W3P82-3571
3-A1.01.04
3-A41

SUBJECT: Waterford SES 3
Docket No. 50-382
Training Qualifications

Certain revisions were inadvertently excluded from our FSAR Amendment 29, docketed on October 26, 1982. These revisions are as follows:

Figure
13.2-1

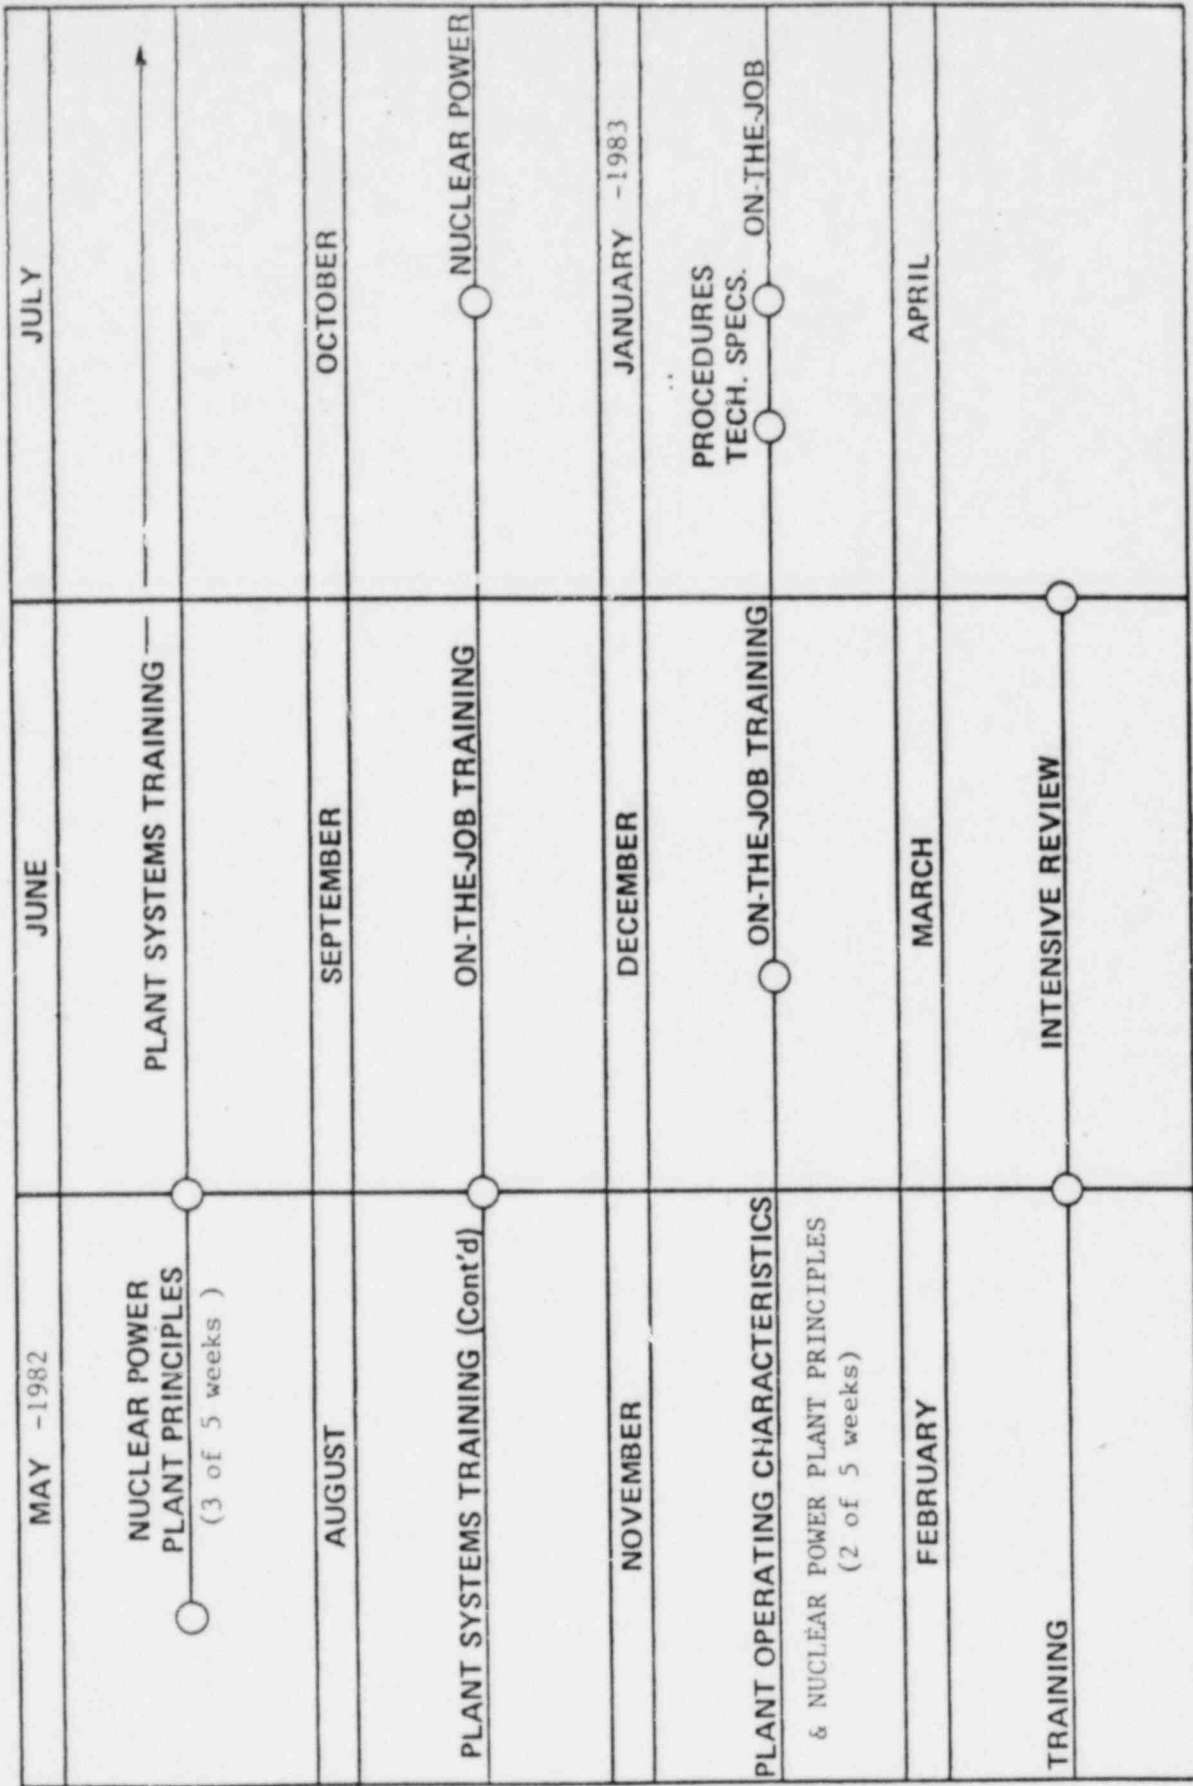
- 1) Table 13.2-1 should be deleted.
- 2) Table 13.1-1 should be supplemented to include Nuclear Training personnel qualifications as attached.
- 3) Page 13.2-3 should indicate that Plant System Training is 12 weeks, not 2, as attached.
- 4) Figure 13.2-1 should be revised as attached.
